647.0110
B116709
REV. A1

Item Name: Roof Doubler

APICAL INDUSTRIES, INC.	ENGINEERING CHANGE NOTICE NO. 03985			SHEET 1 OF 2	
	DWG NO. 647.0100	REV: A	PREPARED BY J. BECKER	DATE: 7/15/13	EFFECT ON DWG ☐ INC. ☒ UNINC.
	DWG TITLE: SHEET METAL				
	APPROVED BY: ENGR 	MFG 	QC 	EFF. NEXT ORDER	
TRANSACTION CODES (TC): A-ADD R-REVISE C-CREATE D-DELETE	REASON: REVISED NOTE 2. ADDED 647.0117

647.0116	DOUBLER	△	△
		647.0115	CLIP	△	△
		647.0114	CLIP	△	△
		647.0113	STRUT DOUBLER	△	△
		647.0112	STRUT BRACKET	△	△
		647.0111	PANEL	△	△
		647.0110	ROOF DOUBLER	△	△
QTY	FIND #	PART #	DESCRIPTION	MAT'L	SPEC.
			PARTS LIST		
NEXT ASSY (S)			APICAL INDUSTRIES		
646.9500			2608 TEMPLE HEIGHTS DR. OCEANSIDE, CA. 92056-3512 (760) 724-5300		
			SHEETMETAL		
			809 2406 CL006 DWG 1	647.0100	REV A
			6 07M26		
			SCALE NONE	SHEET 1 OF 6

SHEET 1, ZONE D1 IS:

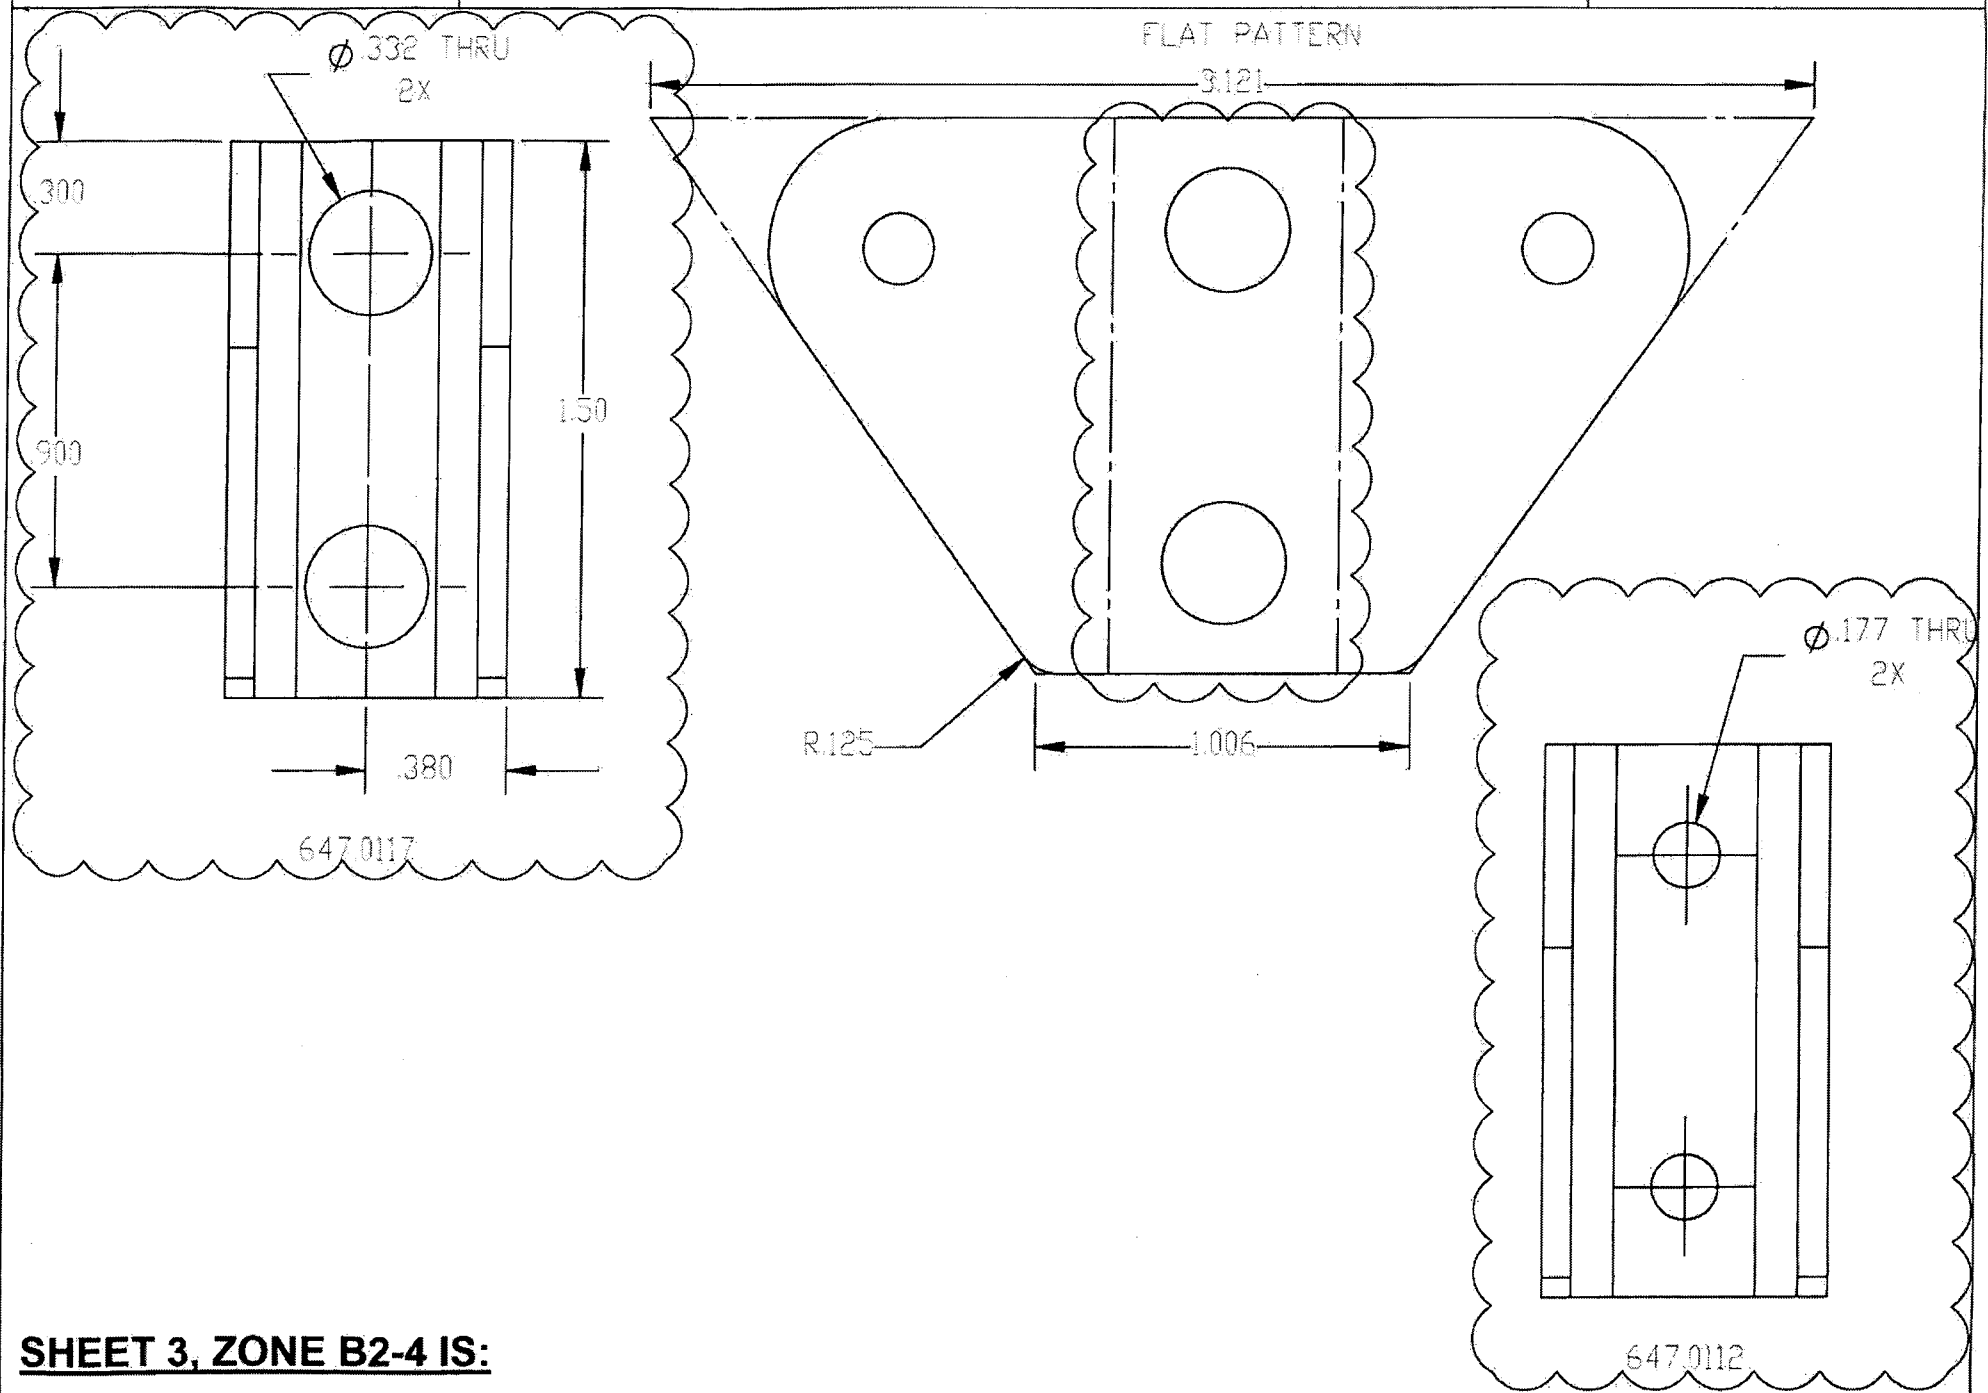
- 1 MATERIAL: ALUMINUM 2024-T3 PER AMS-QQ-A-250/4.
- 2 FINISH: IAW MPP-172 ANODIZE IAW SECTION 2.1, PRETREATMENT IAW SECTION 3.1 AND PRIMER IAW SECTION 4.1.
- 3. DEBURR AND BREAK ALL SHARP EDGES.
- 4. IDENTIFY IAW MPP-120.
- 5 MATERIAL: 304 SS IAW AMS 5643.
- 6 FINISH: PRIME IAW MIL-P-23377J TYPE I CLASS N.
- 7 OTHER DIMENSIONS SAME AS 647.0112.

C	647.0117	STRUT BRACKET		△	△
F/NTC	PART NUMBER	DESCRIPTION		MATERIAL	SPECIFICATION
DOCUMENTS EFFECTED:			CHANGE CATEGORY		
☐ MDL ☐ INSTALL INSTRUCTIONS ☐ ICA ☐ FMS ☐ BOM			☐ MAJOR ☒ MINOR		
			DER REVIEW REQUIRED ☐ YES ☒ NO
